RE: YDI FACILITY- 6303 CENTRAL SW (K-11/D62)
ENGINEERS CERTIFICATION FOR CERTIFICATE OF OCCUPANCY
ENGINEERS STAMP DATED 2/18/2000 Rev. 4/26/2000
ENGINEERS CERTIFICATION DATED 3/12/2001

RE: YDI FACILITY - 6306 West Central Avenue (K11-D62). Revised GRADING AND DRAINAGE PLAN FOR BUILDING PERMIT AND SO#19 PERMIT APPROVALS. ENGINEER'S STAMP DATED APRIL 26, 2000.

RE: GRADING & DRAINAGE PLAN FOR YDI FACILITY (K-11/D062)
SUBMITTED FOR BUILDING PERMIT APPROVAL

RE: YDI FACILITY (K-11/D062)

Project: YDI
Project No.: YDI0100L Date: 4-23-00
Subject: POND VOL. CALCS.
By: JSR Sheet 1 of 1

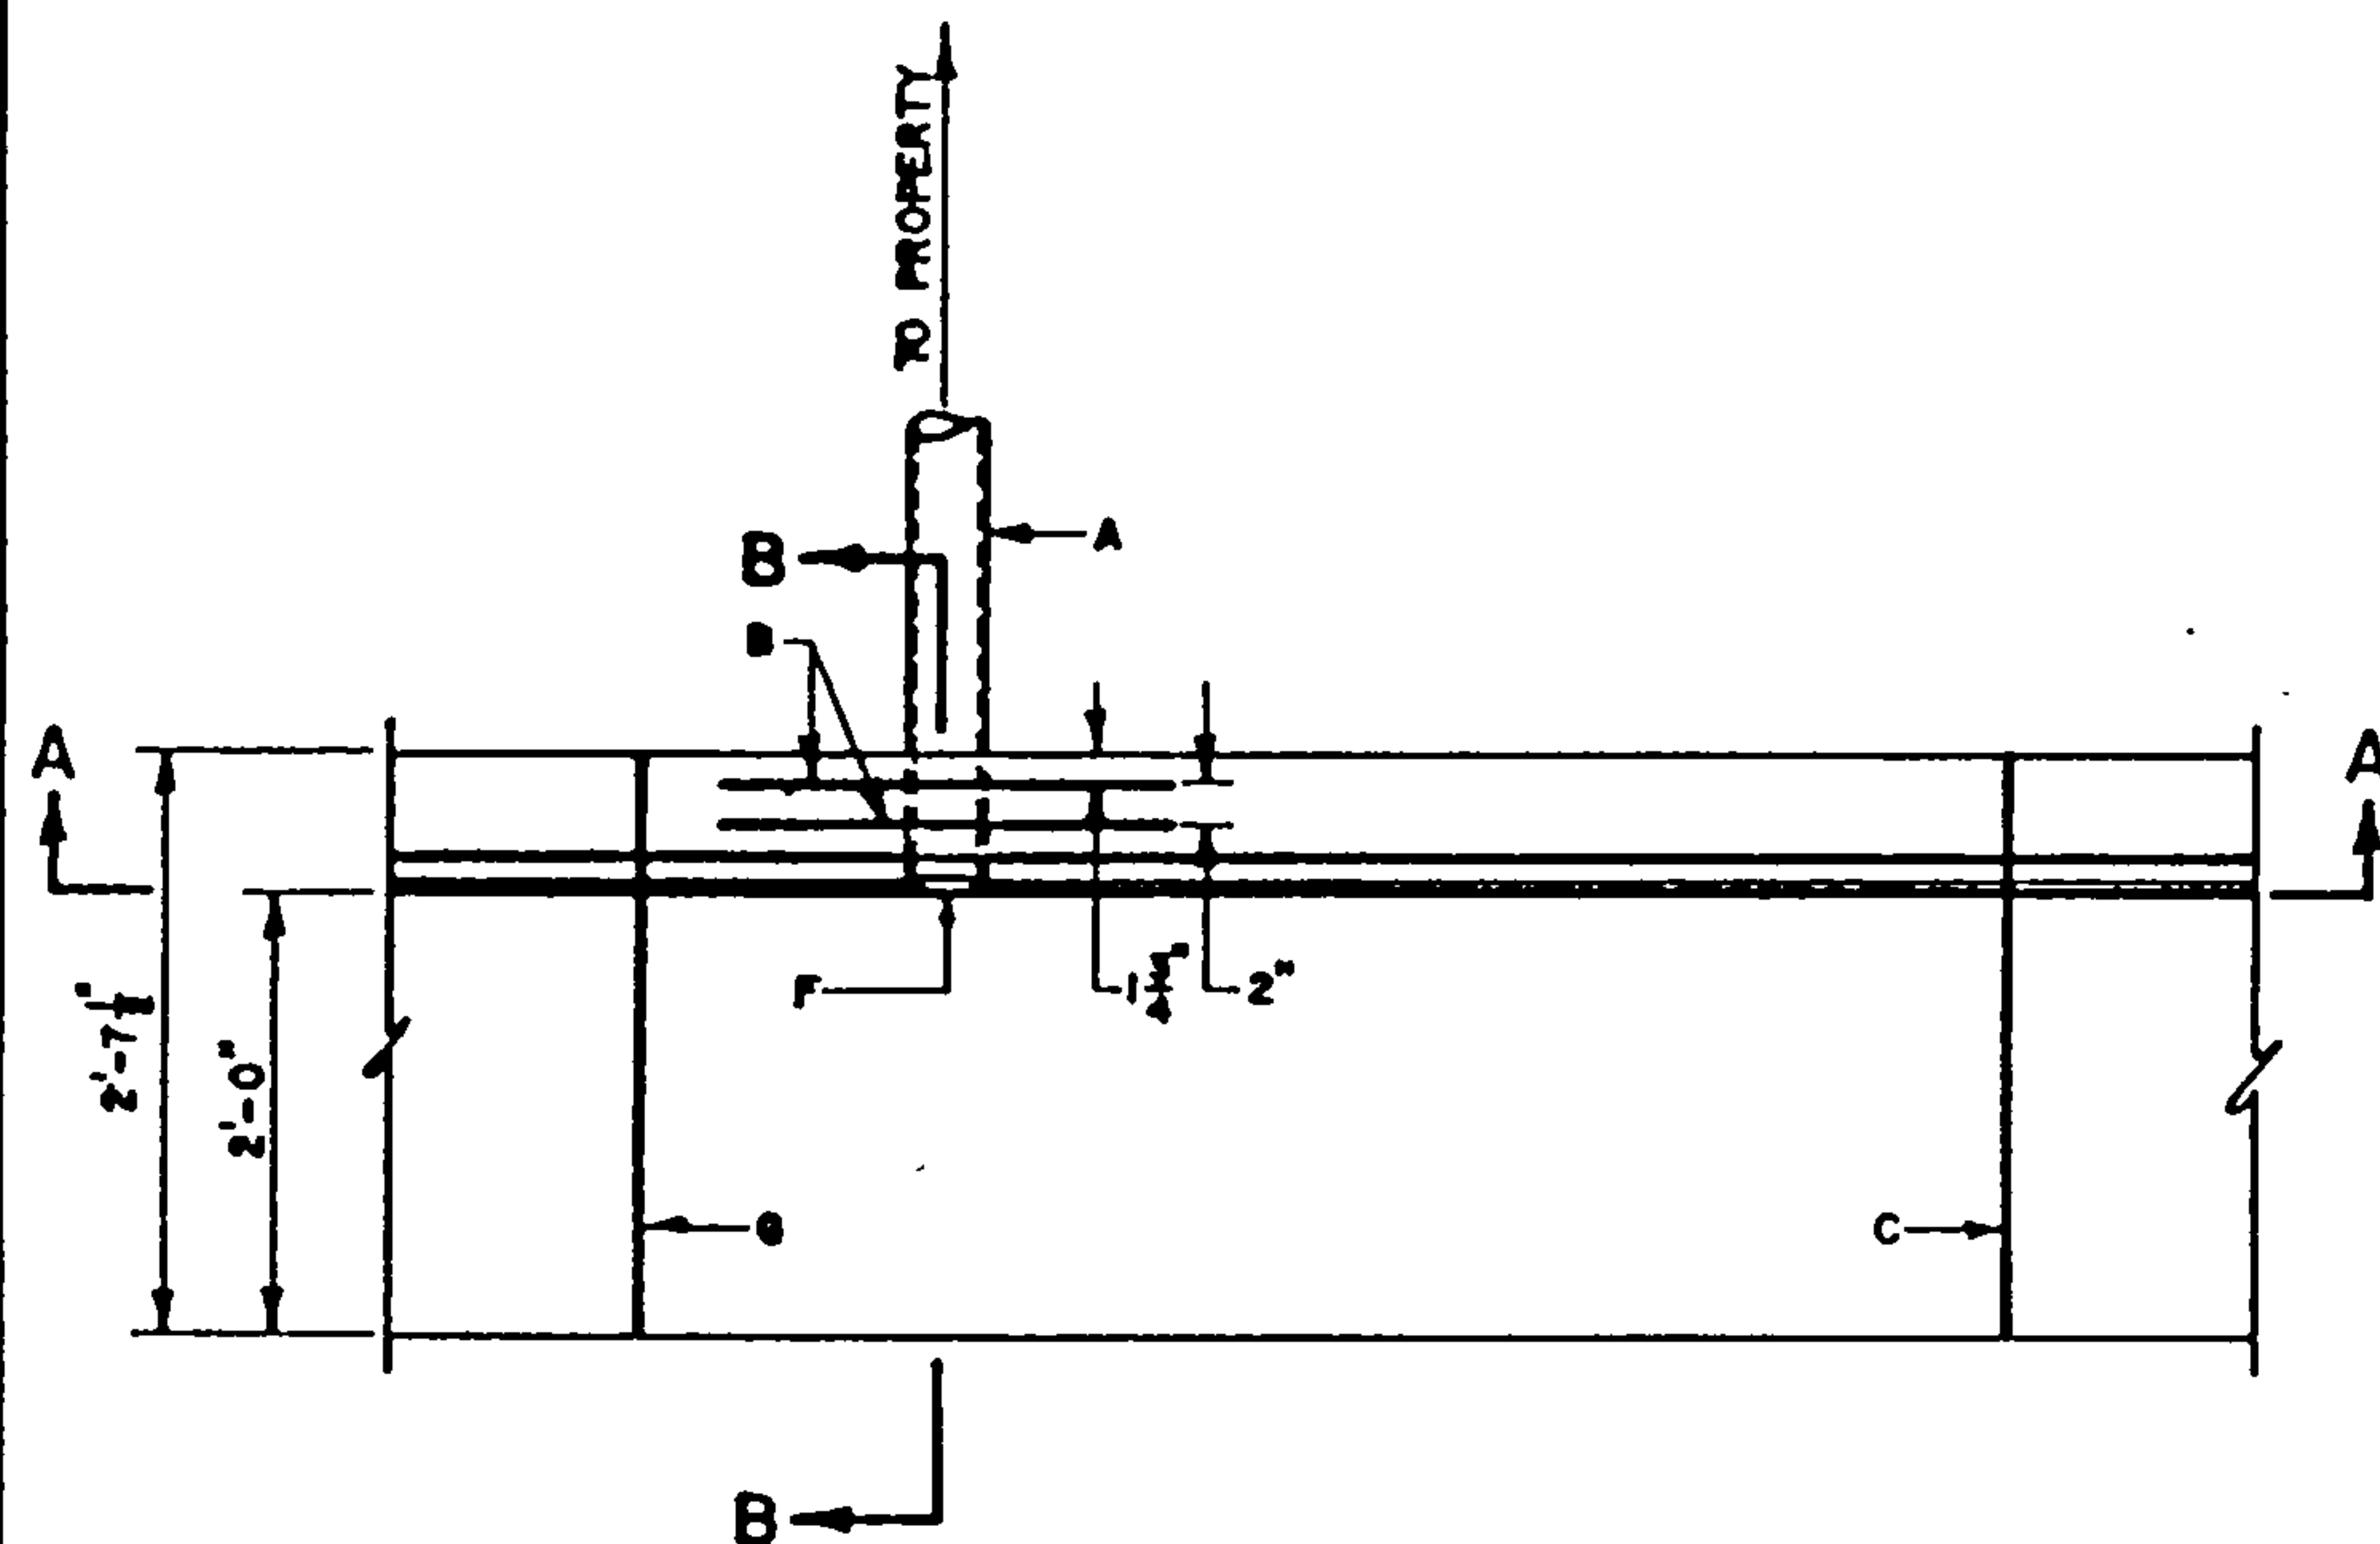
1. Under *EXISTING CONDITIONS*, please describe how the site drains, or fails to drain, at present.
2. Please provide existing and proposed grades per the DPM standards for drainage plans. Please use the standards for flow arrows, contour lines and so on.
3. Two flow lines and proposed grades indicate that the parking lot will discharge onto the neighboring property through curb openings. Without a drainage easement across that property, the owner of the YDI Facility may not continue to discharge in this manner.
4. Finally, you must provide some means for draining the pond; retention ponds are not allowed.

DETENTION POND VOL:

TOTAL		352 CF. (PROVIDED)
-------	--	-----------------------

~~PROVIDED~~ = 324 CF. ✓ OK
